**Comments on the
April 2006 Draft Specifications
for
High Efficiency Toilets
Compiled on July 12, 2006**

Comments on the Draft Specifications for High Efficiency Toilets

**Illustration of Bulk Load Test Results
Theoretical vs Actual Bagged Miso**

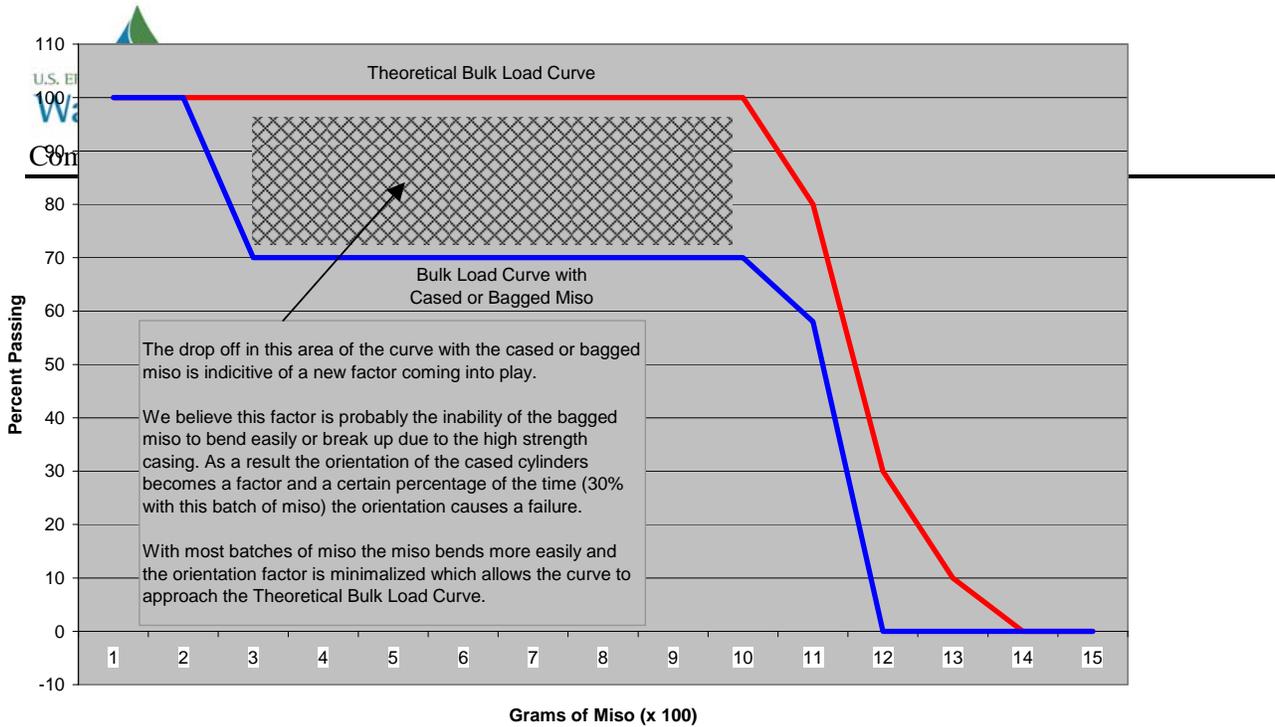
Exhibit C is a graph which shows two lines. One is the Bulk Load Curve with Bagged (cased) Miso. This is the information from Exhibit B with the results from 300 grams through 1000 grams smoothed to the average result of approximately 70%. The second line is the Theoretical Bulk Load Curve which has been created for illustration. The basic difference between these two curves is the area cross hatched in the load range of 300 to 1000 grams

The Theoretical Bulk Load Curve explains the behavior of a good bulk media test. At low levels of loading, imagine 10, 20, or 30 grams of the original (uncased) soybean paste test media, the bowl will pass the media 100% of the time. Likewise at very large levels of loading, imagine 2000, 3000, or 4000 grams of the original (uncased) soybean paste test media, the bowl will pass the media none of the time. At some point between these two extremes the bowl will transition between passing the media 100% of the time to passing the media none of the time. This transition generally occurs over a relatively short level of loading as shown on the Theoretical Bulk Load Curve, at 1100 grams it starts to drop off and by 1400 grams it is down to 0.

The Bulk Load Curve with Bagged (cased) Miso implies that the transition from passing to not passing the media begins at 300 grams and continues up to 1200 grams. This drawn out transition with a four fold increase in load seems unrealistic. Also, the transition drops immediately from passing 250 grams 100% of the time to only passing 300 grams 70% of the time and then the 70% level is held clear up to 1000 grams. Further, the 70% pass rate is held to a very tight tolerance, plus or minus 4%. Clearly something else is happening. As mentioned in the note on the graph, "We believe this factor is probably the inability of the bagged miso to bend easily or break up due to the high strength casing. As a result the orientation of the cased cylinders becomes a factor and a certain percentage of the time (30% with this batch of miso) the orientation causes a failure." It then goes on to state that, "With most batches of miso the miso bends more easily and the orientation factor is minimal which allows the curve to approach the Theoretical Bulk Load Curve."

We believe that with the majority of shipments of cased soybean paste test media they tend to bend easily, so what we observed with the March shipment would not occur and the bulk load curve would resemble the theoretical curve and the results would thus be similar to the original (uncased) soybean paste test. However with at least one shipment we found the results shown in Exhibit B and plotted in Exhibit C. We don't know how frequently this will happen, to date we have found one out of five. However, from exhibit A we can surmise that it happens to a lesser extent somewhat frequently, two out of five times, as we had results either somewhat above average late in 2005 (1200-1400) or somewhat lower than average in May (700-900).
